Comhairle Contae Chorcaí Cork County Council

Subject: WWDL Application For Kanturk REF NO.D0203-01
Response to Notice issued by EPA in accordance with Regulation 18(3)(b) of the Waste Water Discharge
(Authorisation) Regulations 2007 – dated 14th January 2009

REGULATION 18(3)(b) REPLY DATED 11th MARCH 2009

APPLICATION NO. D0203-01

Title:
 Attachment B2
 1:2500 Wastewater
 Treatment Plant Site Plan

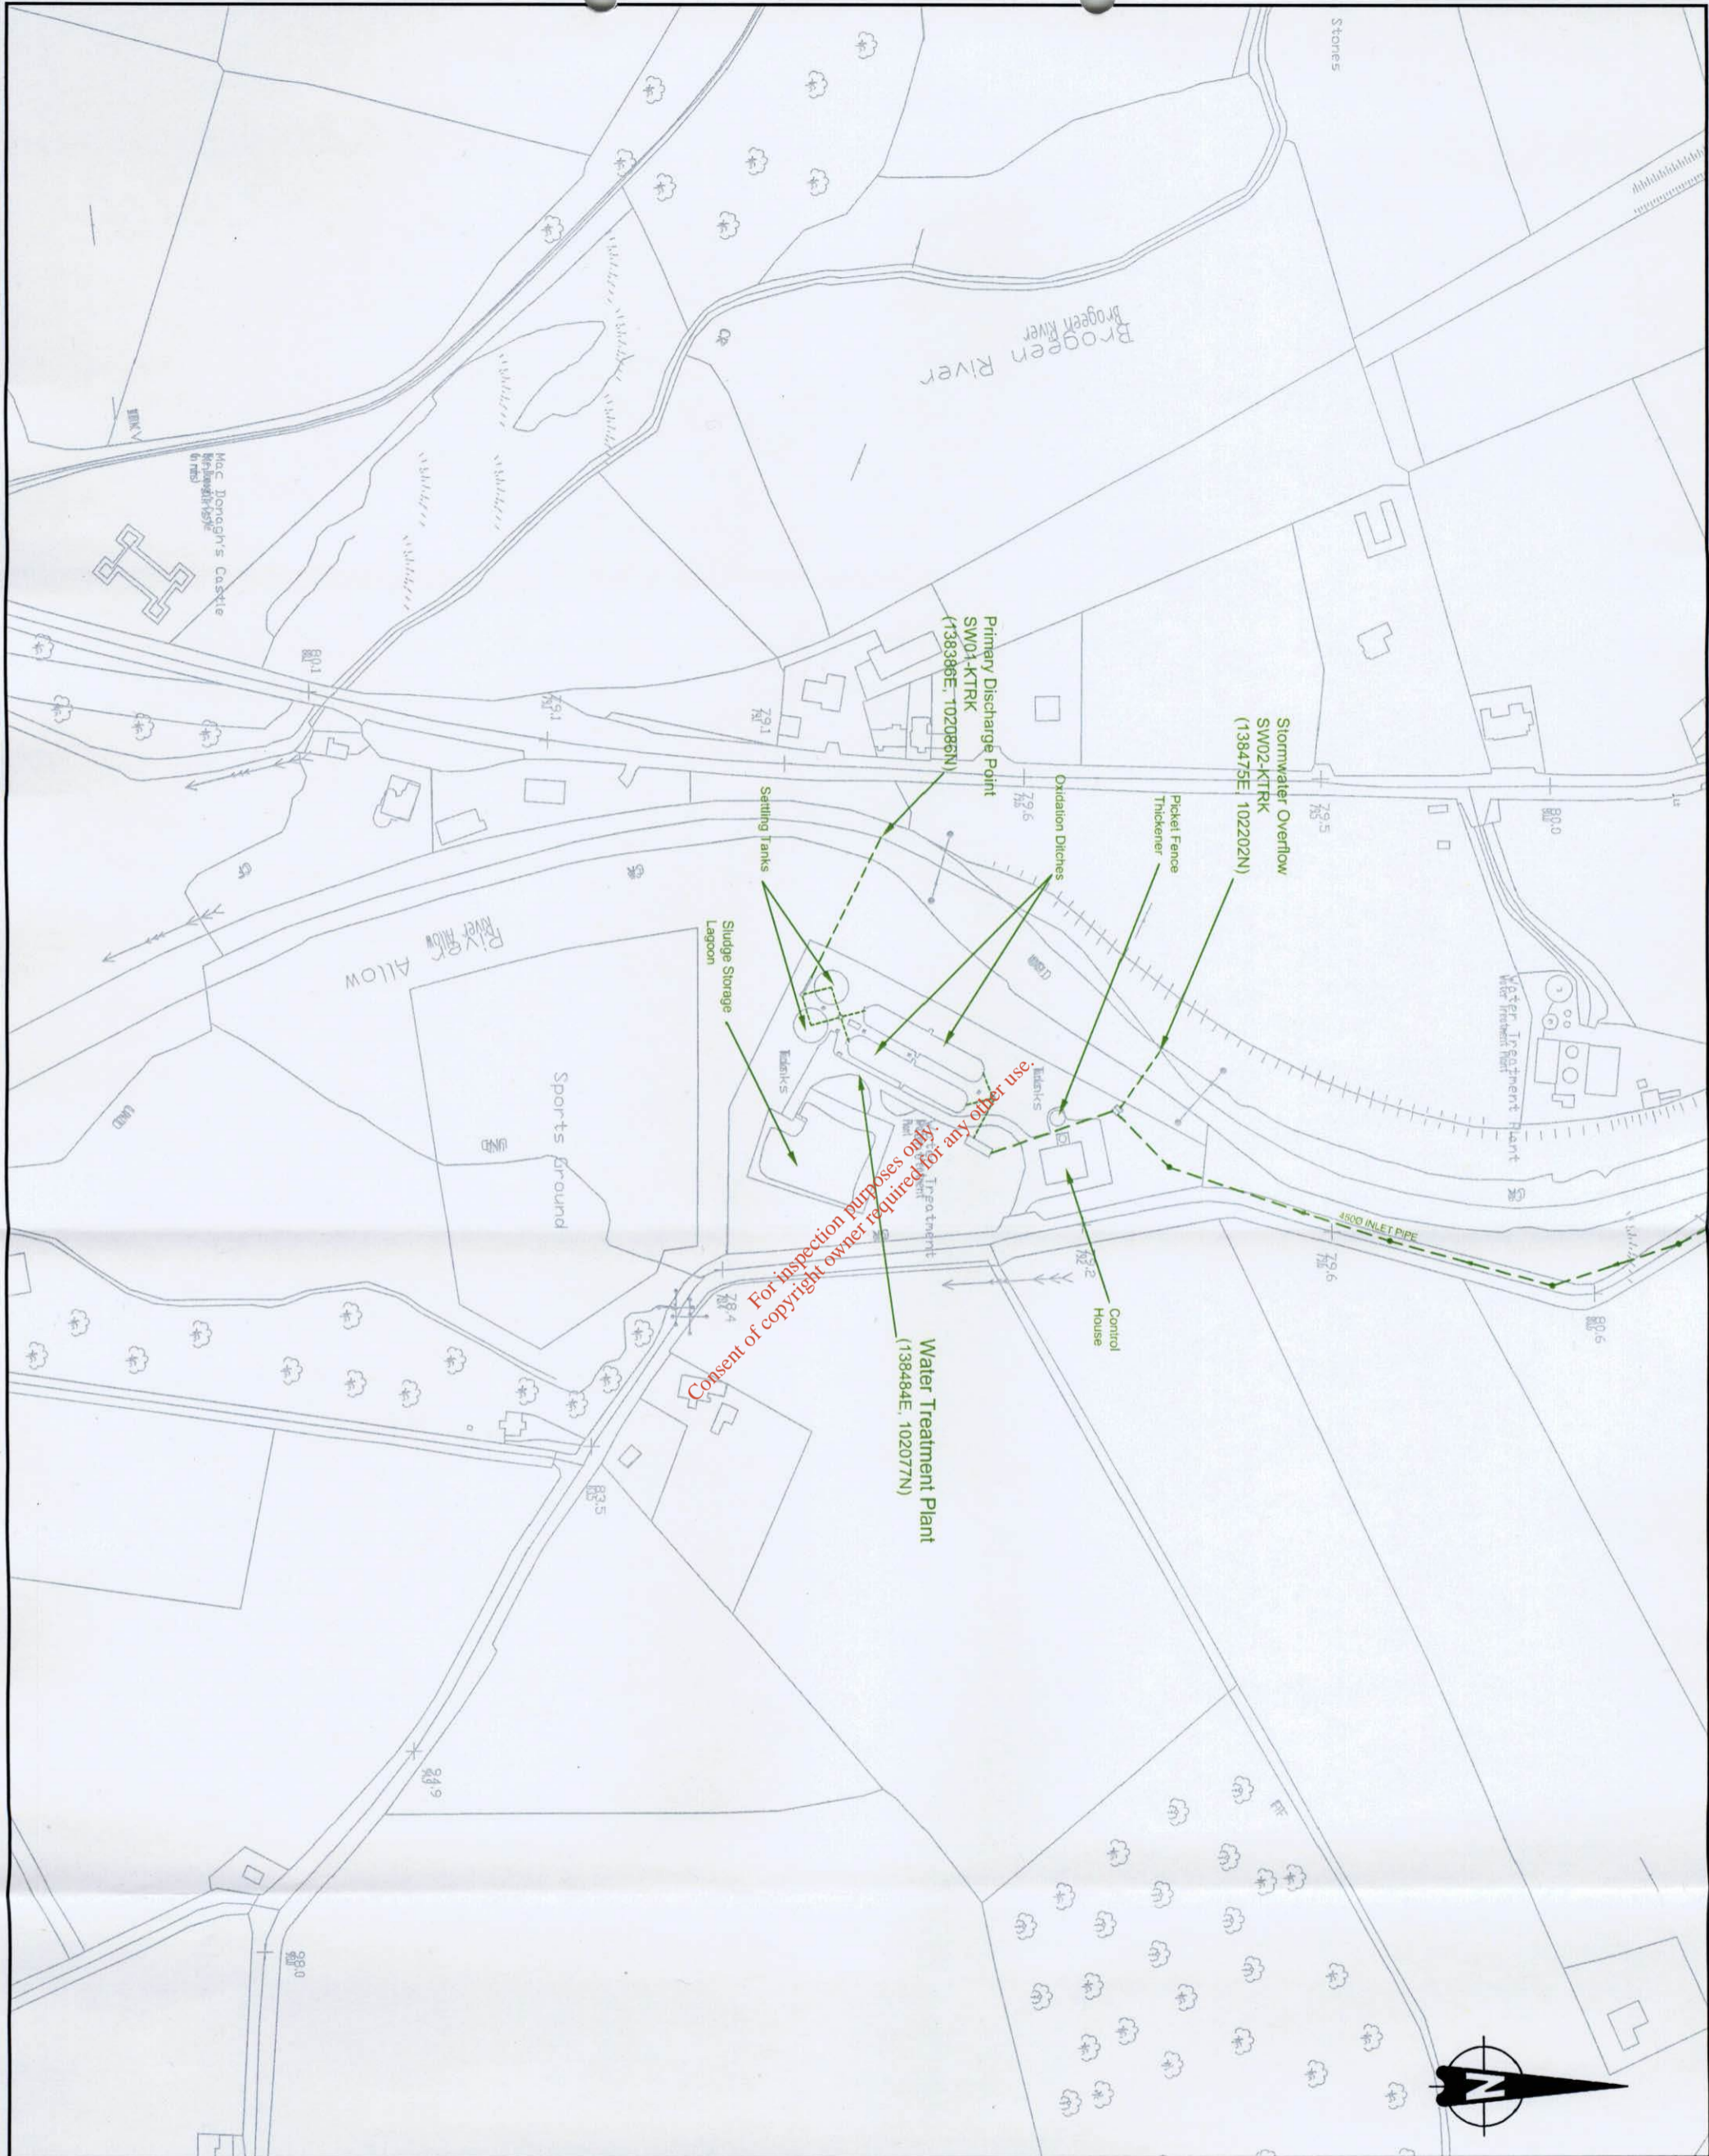
In addition Drawings KTRK B2-03 and KTRK B3-05 have been updated to reflect the redesignation and Revisions A02 of the drawings are included in Attachments B.2 and B.3, respectively.

Title	Number	Previous Revision	Current Revision
1:2500 Wastewater Treatment Plant Site Plan	KTRK B2-03	A01	A02
1:10,000 Location Plan of All Discharge Points	KTRK B3-05	A01	A02

Item	Title	Revised Drg. No.	To Replace Drg. No.
1	Revised 1:2500 Wastewater Treatment Plant Site Plan, KTRK B2-03	KTRK B2-03 (Rev. A02)	KTRK B2-03 (Rev. A01)

Title:
Attachment B5
1:500 Location Plan of Secondary
Discharge Point, SW02-KTRK

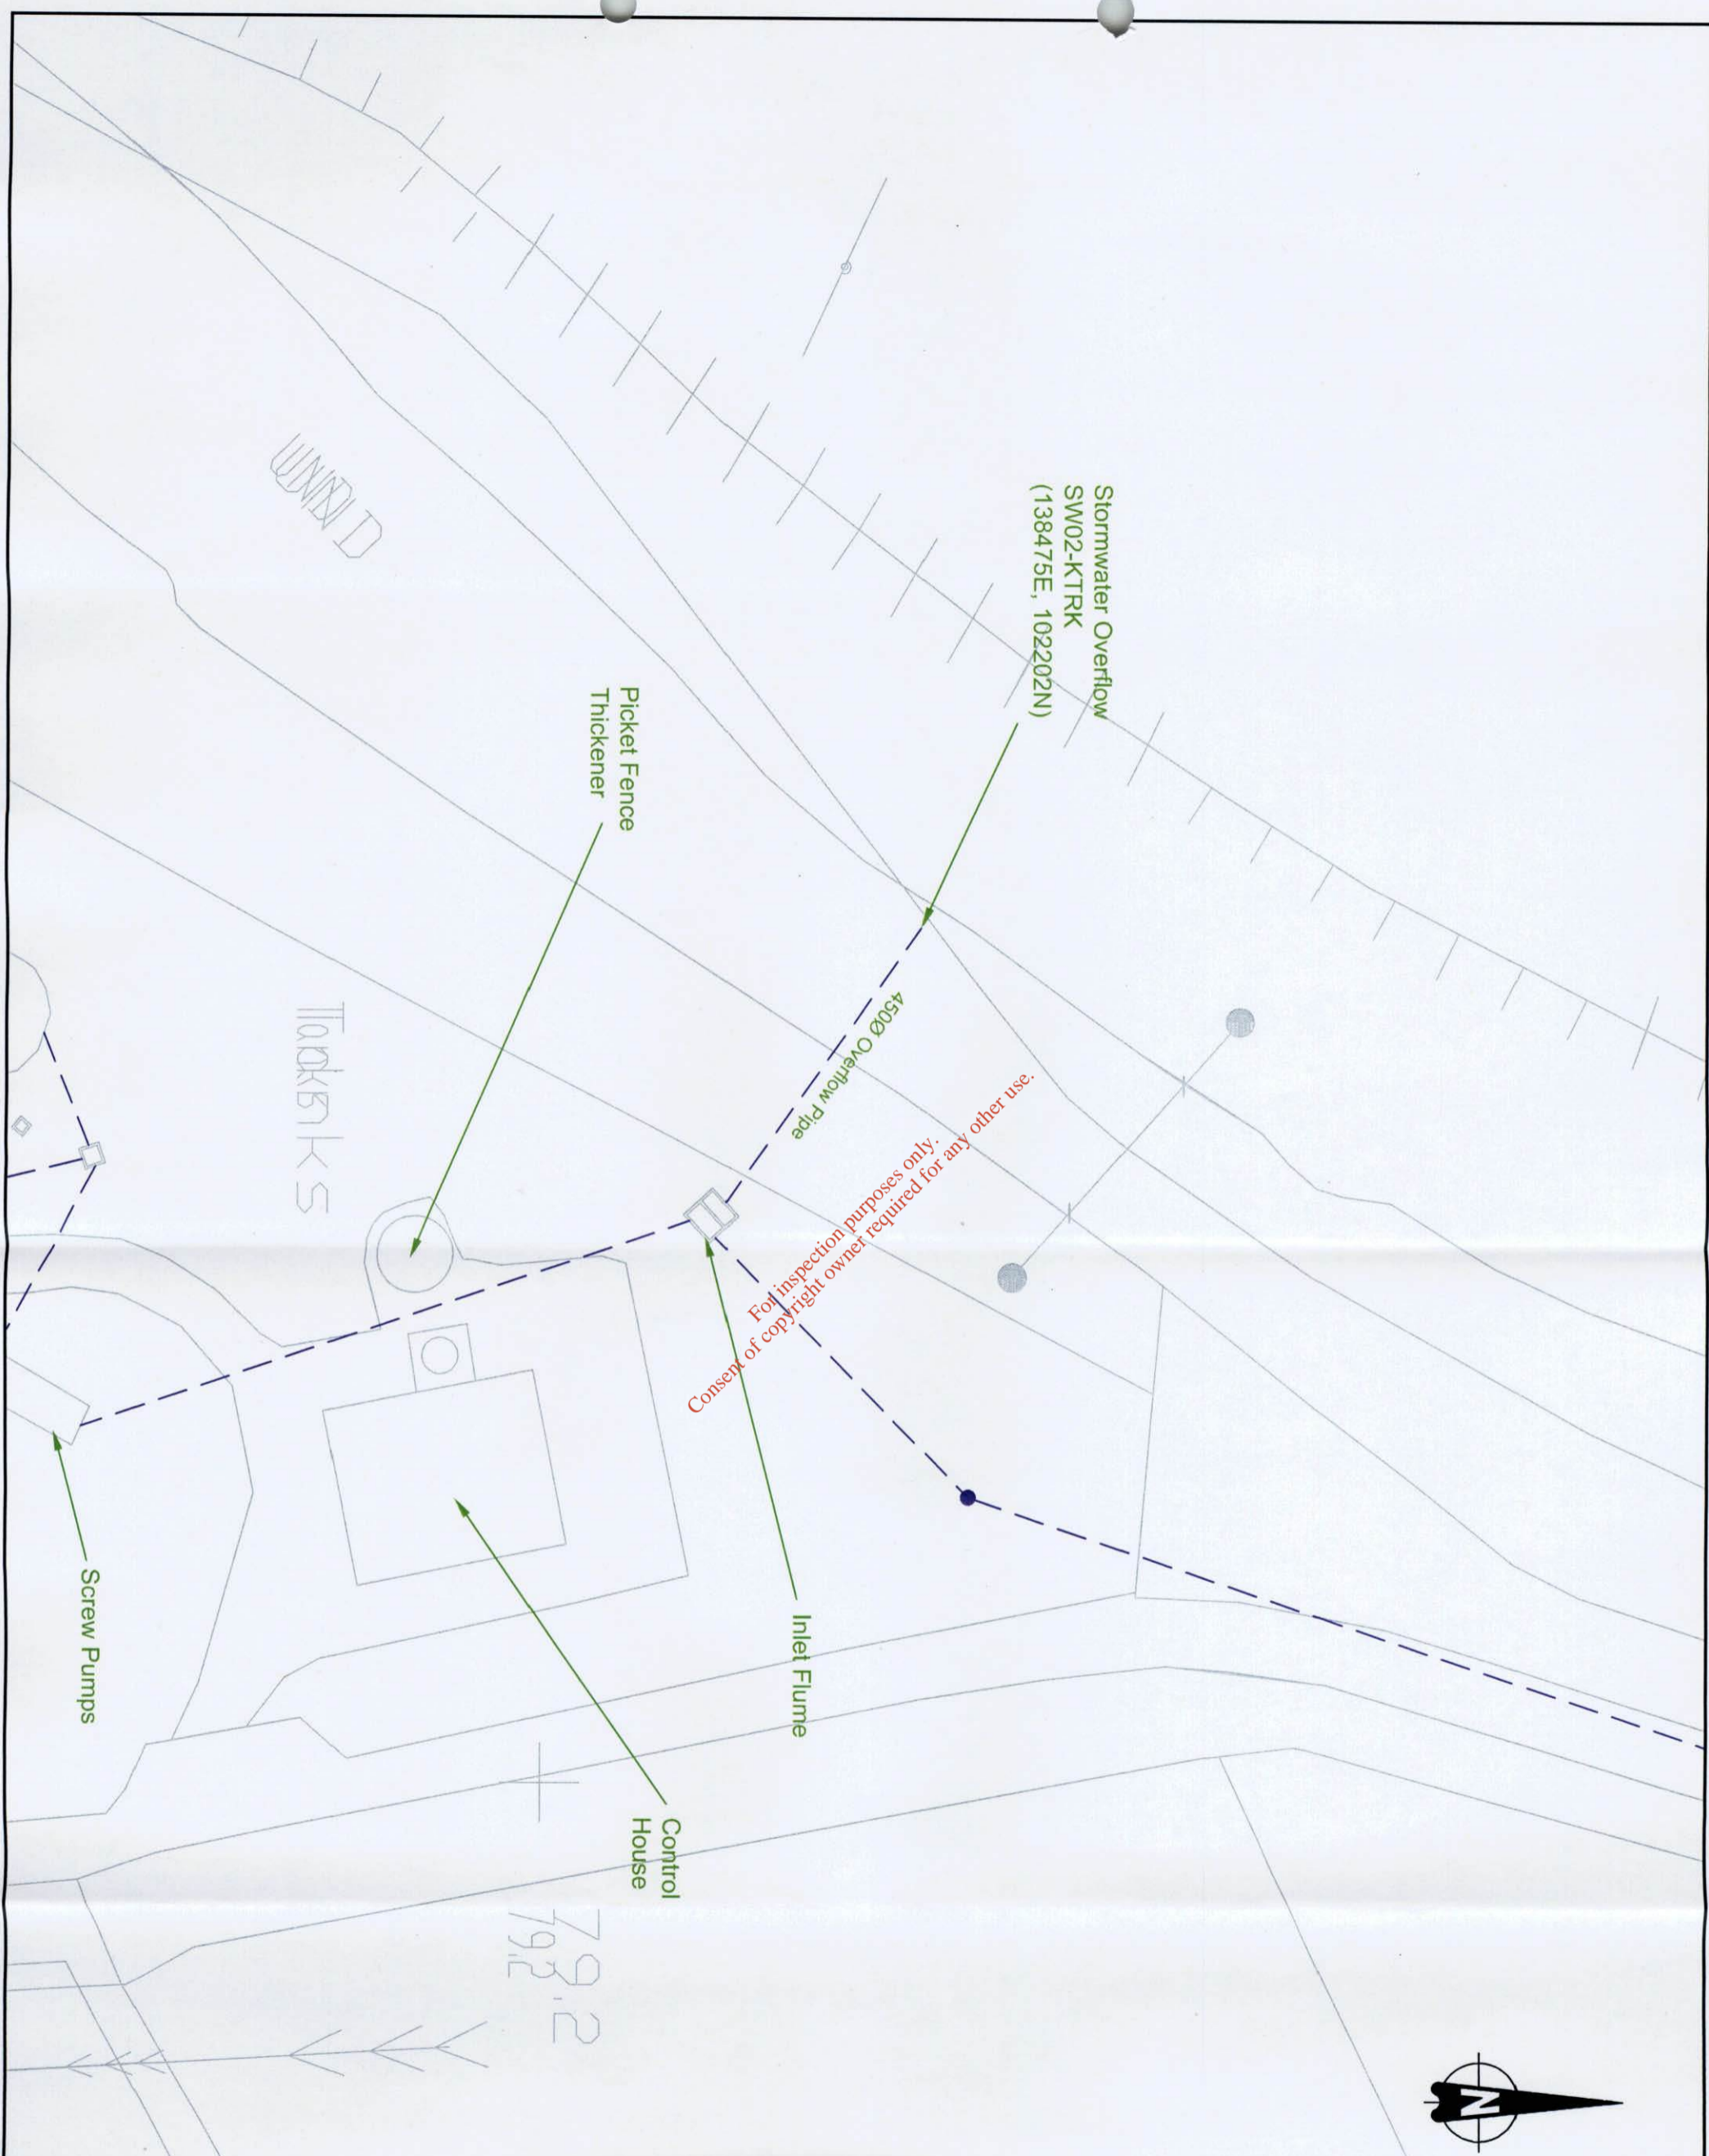
Upon reassessment of the two designated secondary discharges (SW02-KTRK and SW03-KTRK), the emission points have been redesignated as stormwater overflows, with the same designation codes.

As a result of the redesignation the following drawings are withdrawn from Section B.4 and replaced with drawings in Section B.5 according to the table below:

Withdrawn Drawing		Replacement Drawing	
Number	Title	Number	Title
KTRK B4-08	1:500 Location Plan of Secondary Discharge Point, SW02-KTRK	CHVE B5-08	1:500 Location Plan of Stormwater Overflow, SW02-KTRK
KTRK B4-09	1:500 Location Plan of Secondary Discharge Point, SW03-KTRK	CHVE B5-09	1:500 Location Plan of Stormwater Overflow, SW03-KTRK

The locations of the stormwater overflows are shown on Drg. Nos. B5-08 and B5-09 included in Attachment B.5.
